## CONTINUING ELIGIBILITY INSPECTION (CEI) REPORT

FOR FLOOD CONTROL WORKS

1. Project Name: Kahoma Stream FCP

2. Date of Inspection: October 31, 2003

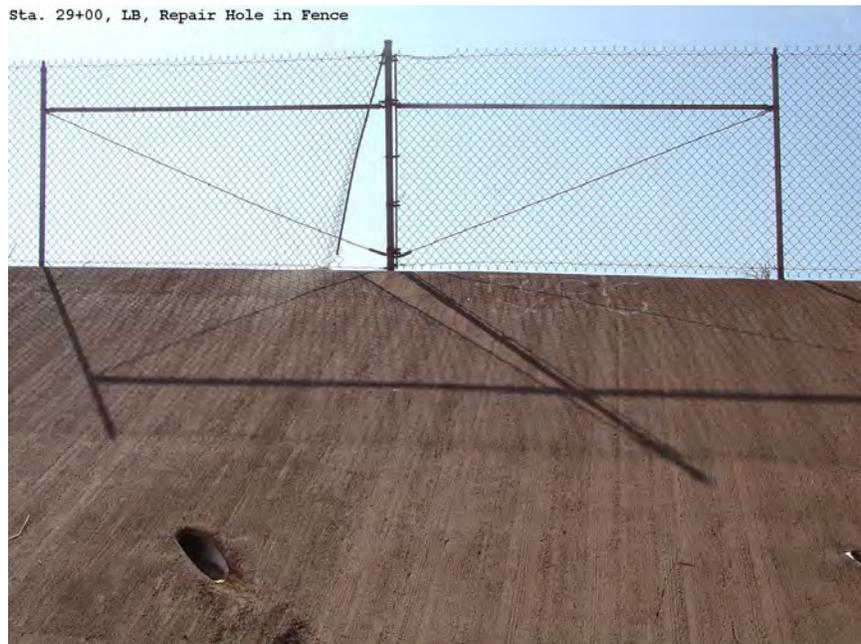
i. Sta. 45+00 to 42+49, channel, monitor hollow invert patch. Patch may have been a result of construction work to correct a late design change; moving grooved concrete swale.

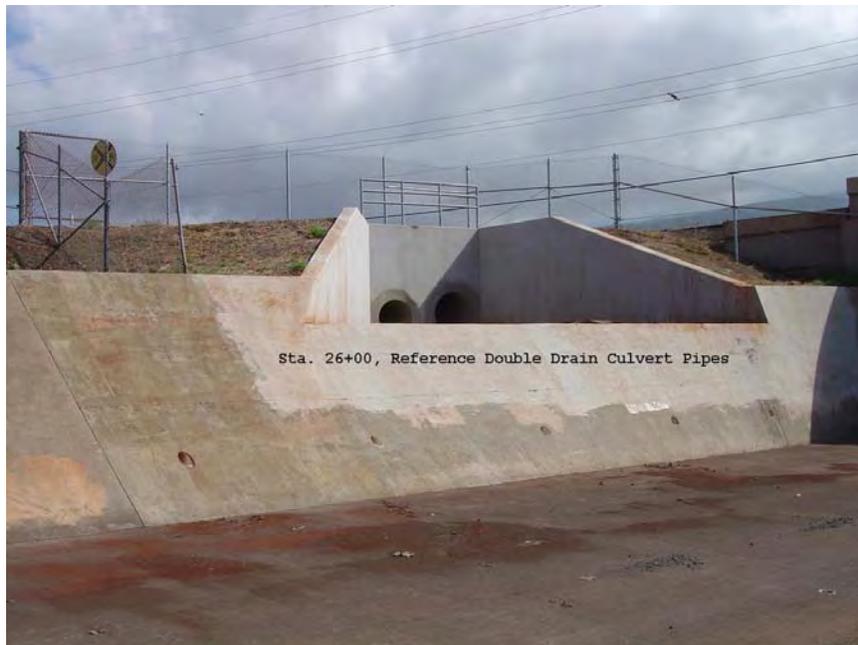
k. Sta. 29+00, LB, Re-hang Fencing.
